Response to city comments issued from the City of Albuquerque on April 22, 2022.

Response to
 Transportation
 Development Comments

Chase US66 & Coors
 111 Coors Blvd NW
 Albuquerque, NM 87121

OVERALL SITE PLAN (FOR REFERENCE)

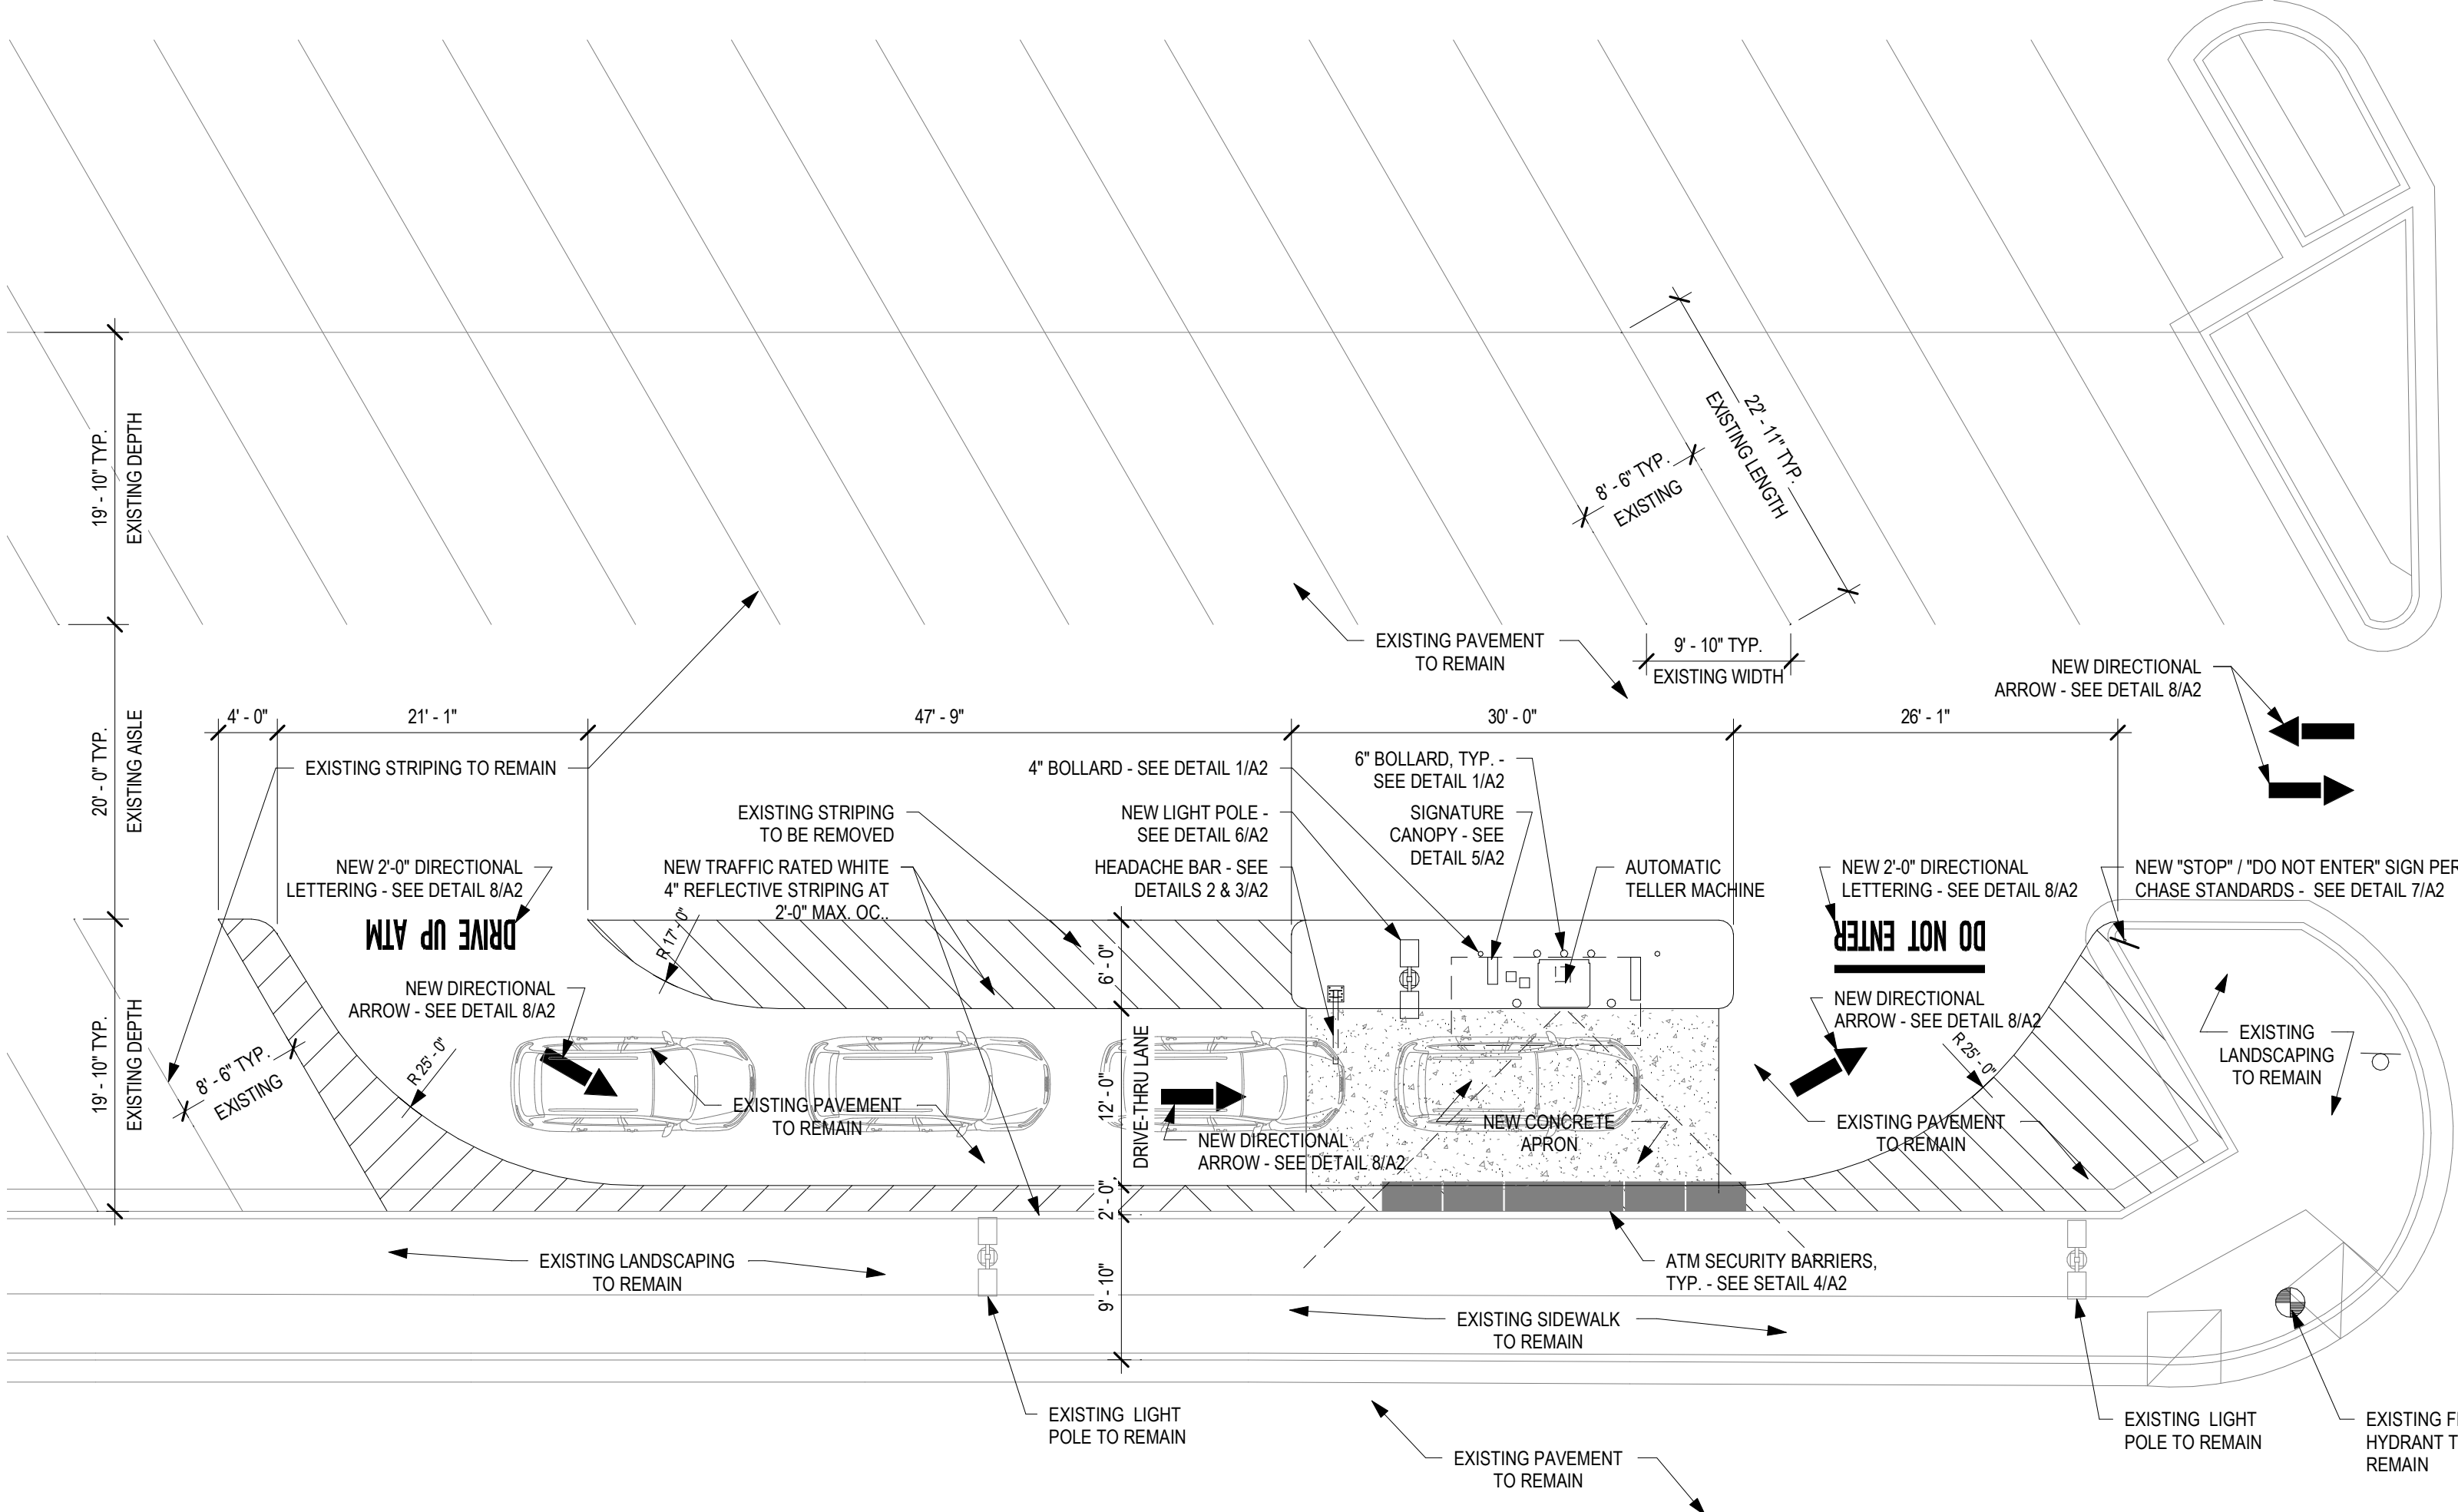
1. Comment: Please List the number of parking spaces required by the IDO as well as the proposed number of parking spaces including bicycle and motorcycle parking. Contact Zoning for parking calculation requirements. I talked with zoning about your previous response to this comment, and they said you still need to do the parking calculation.

Response: Parking data based on the IDO has been added to the Project Data on sheet A1.
2. Comment: Show the dimensions of the existing parking spaces on site plan.

Response: Standard dimensions of the existing parking spaces have been added to the Overall Site Plan and Enlarged Site Plan at Drive Up ATM showing typical parking space dimensions on sheet A1.

2
A2.1 **ACCESSIBLE & VAN ACCESSIBLE PARKING SIGNS**
SCALE: 1 1/2" = 1'-0"

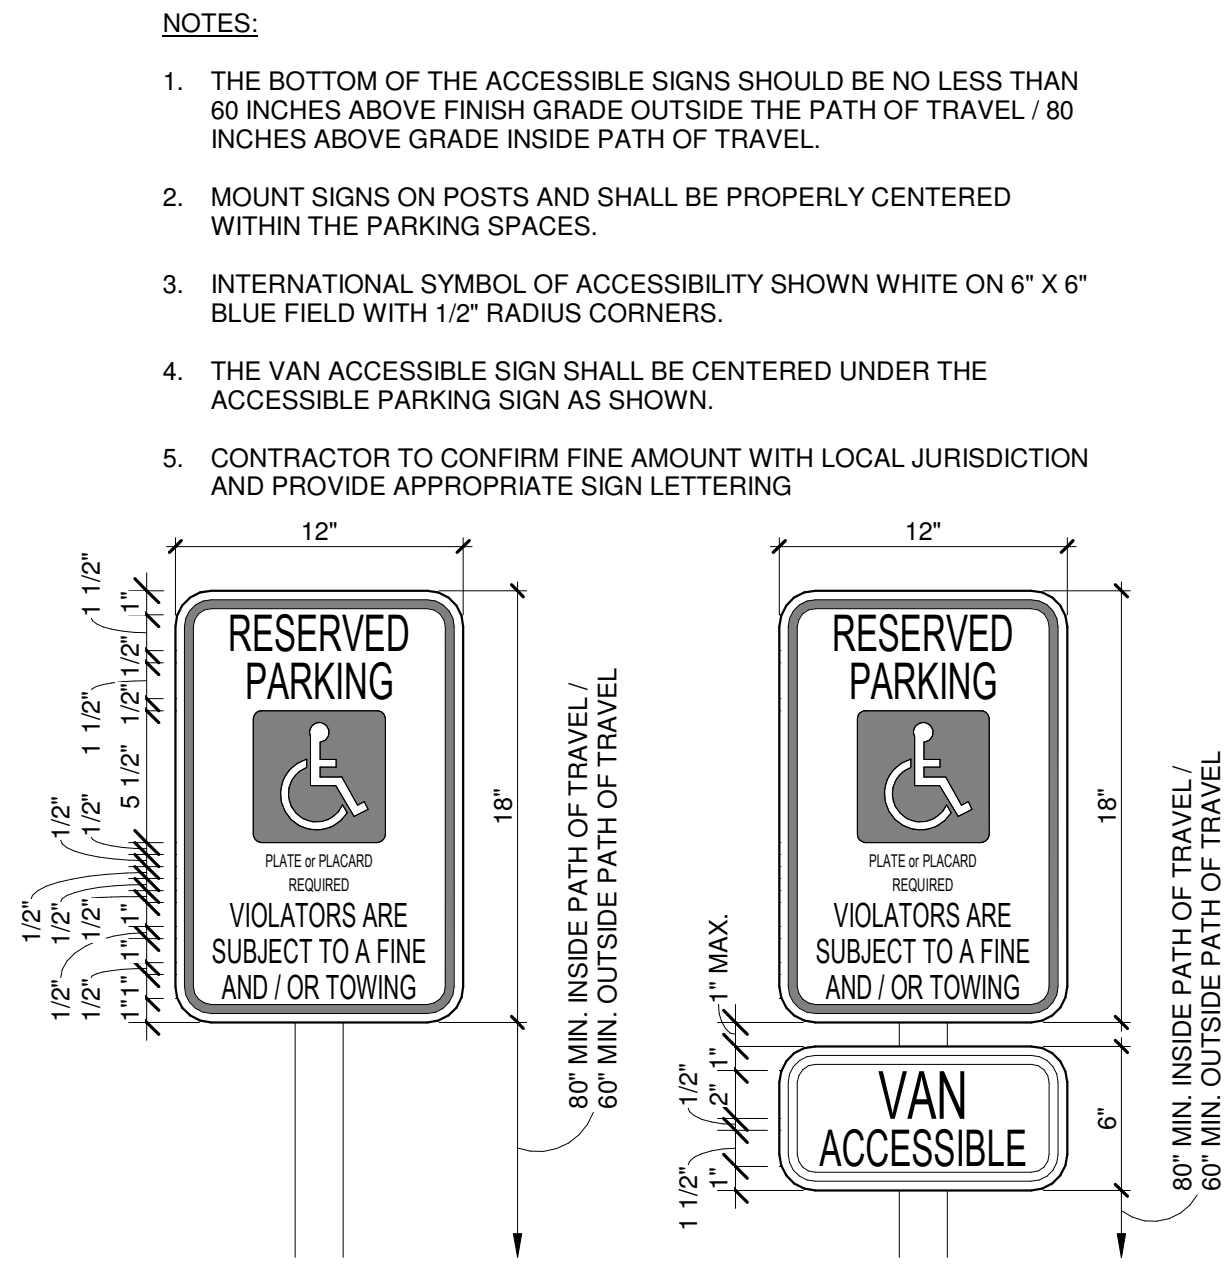
5. Comment: The ADA accessible parking sign must have the required language per 66-7-352.4C NMSA 1978 "Violators Are Subject to a Fine and/or Towing." Please call out detail and location of signs and provide face sign details.

Response: Added Accessible & Van Accessible Parking Signs detail 2 on sheet A2.1 which has verbiage matching NM statutes. Sign locations are called out on Enlarged Plan at Accessible Parking Stalls detail 1 sheet A2.1.

1
A2.1 **ENLARGED PLAN AT ACCESSIBLE PARKING STALLS**
SCALE: 1/4" = 1'-0"

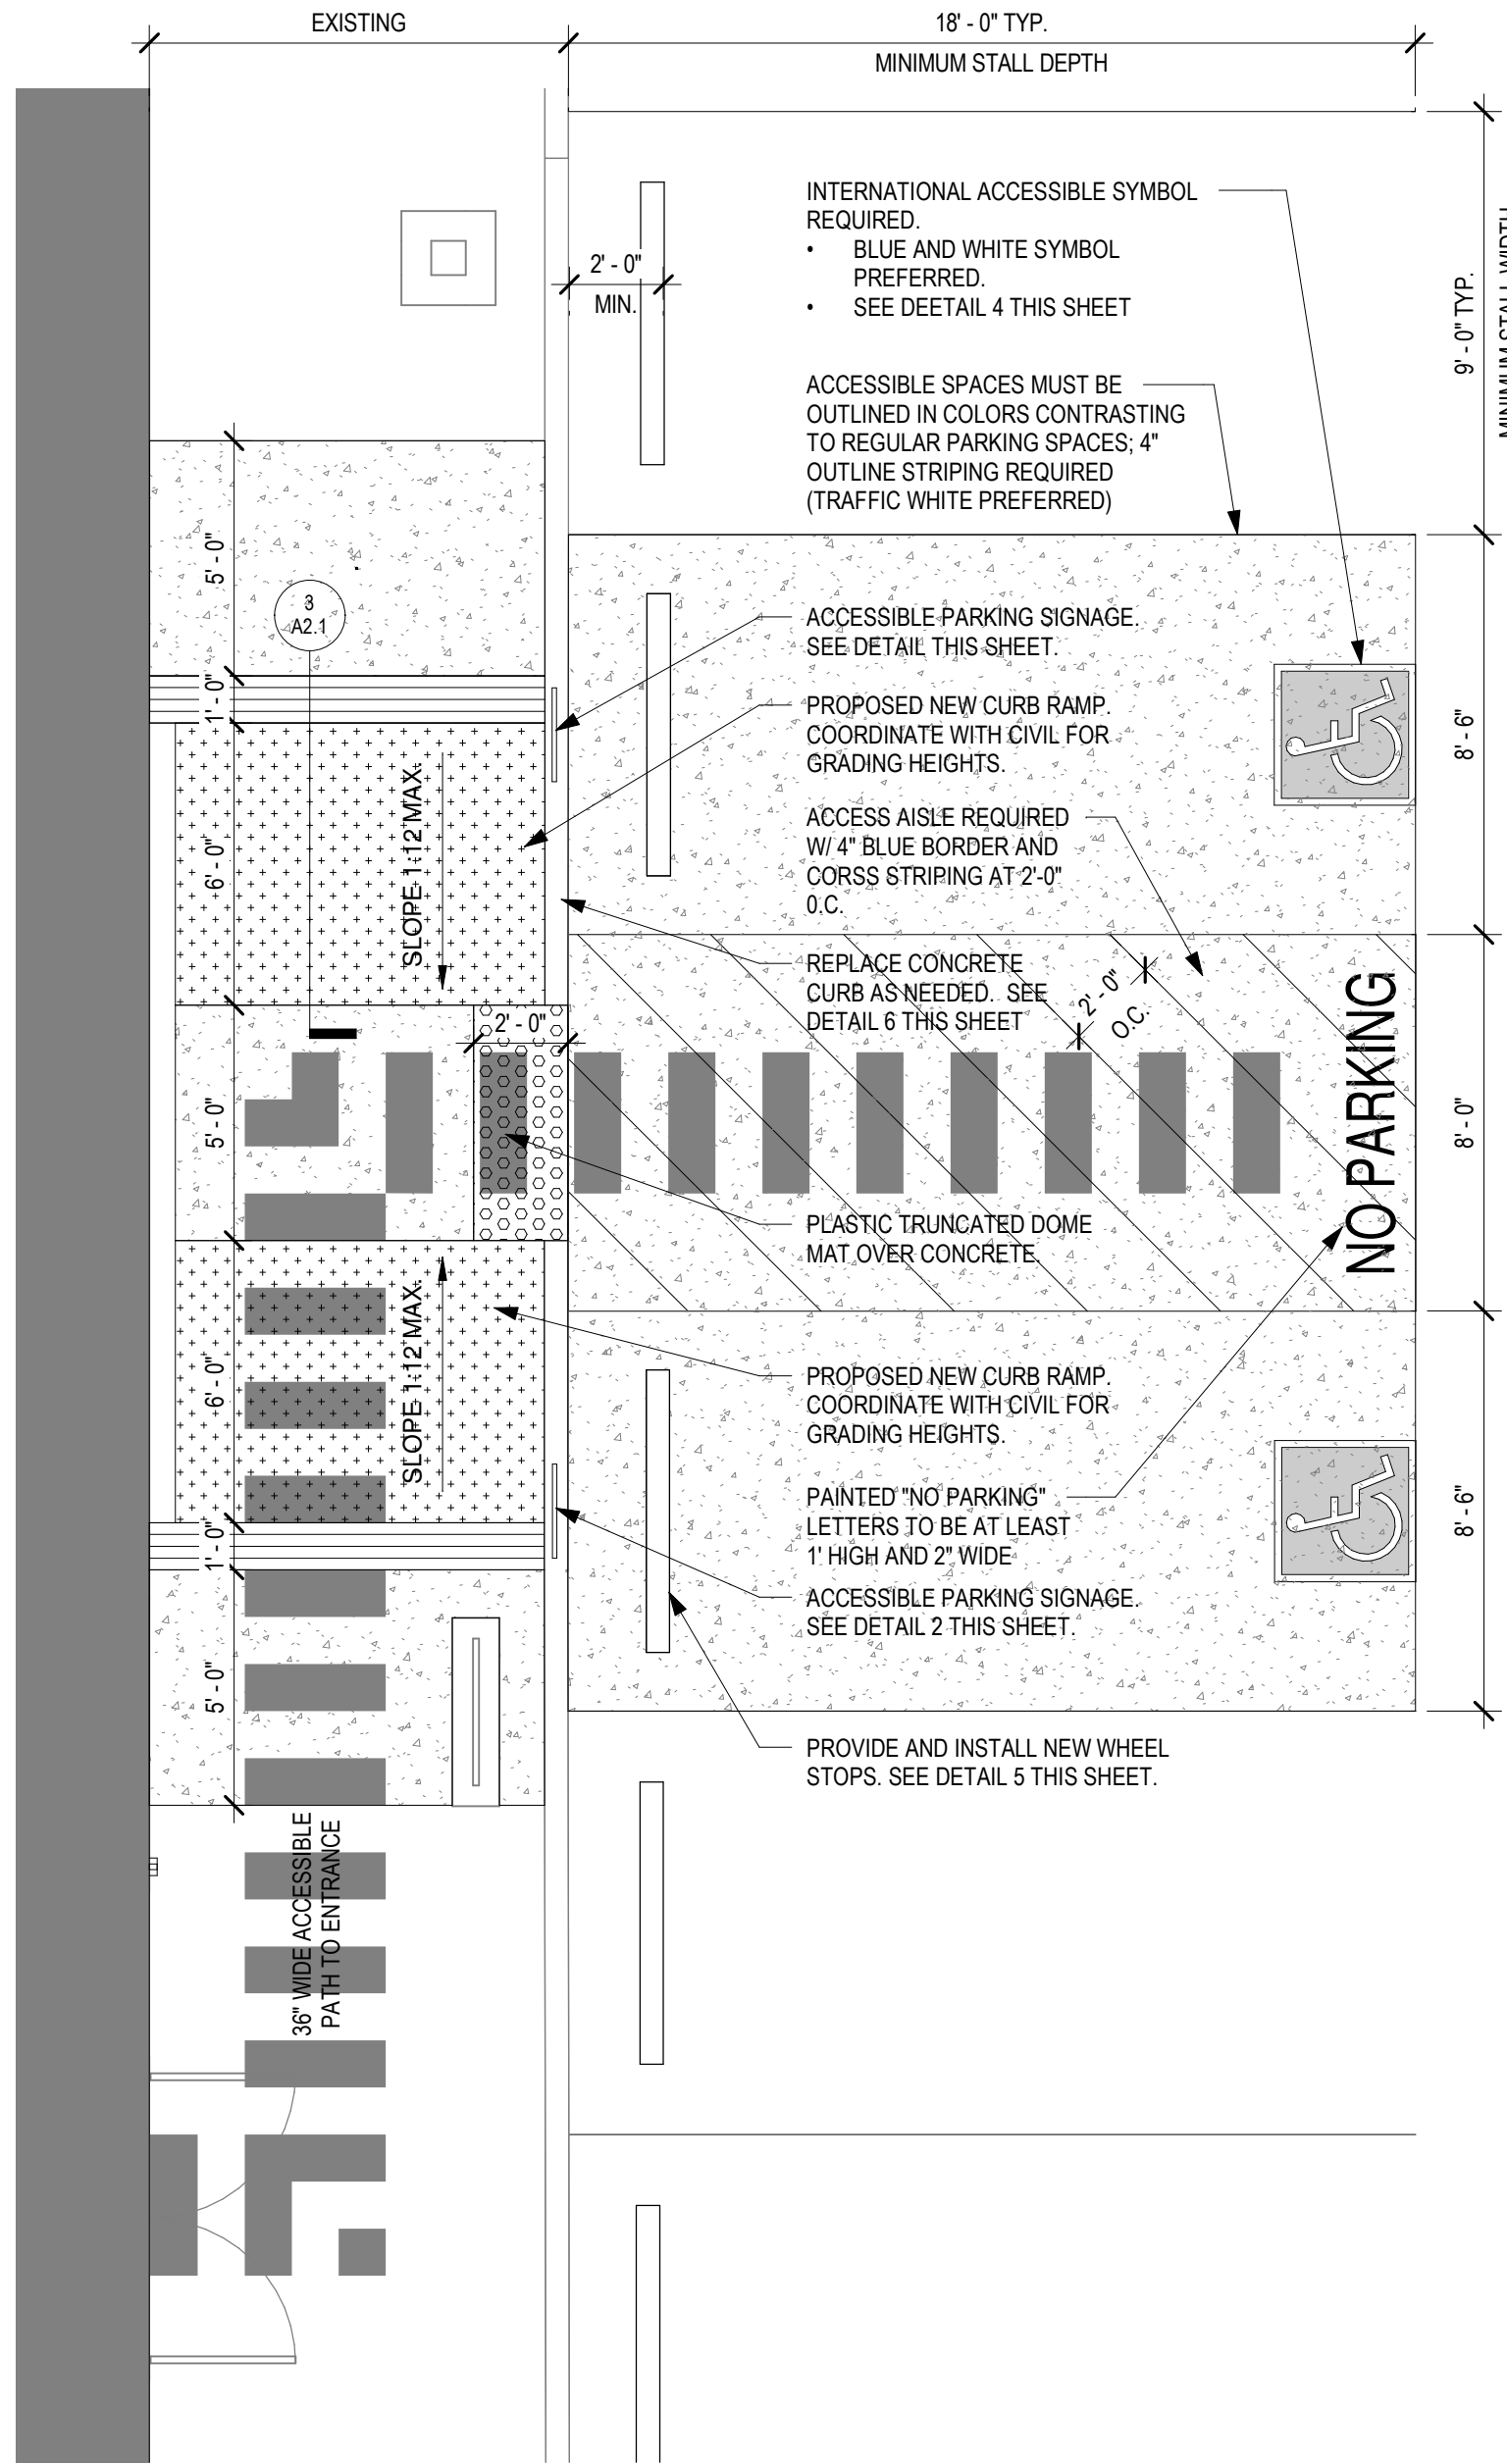
3. Comment: Please update the existing ADA parking spaces and the existing ramp to the current standard.
Response: All ADA parking spaces and curb ramps related to this project will be updated to current standards. ADA parking Enlarged plan is shown on detail 1, sheet A2.1.

4. Comment: Show on site plan the ADA pathway from each ADA aisle to the building entrance.
Response: The existing ADA pathway to public ROW is shown on Overall Site Plan on sheet A1. ADA pathway from new ADA parking to new bank entrance has been added to Enlarged Plan at Accessible Parking Stalls detail 1 sheet A2.1.
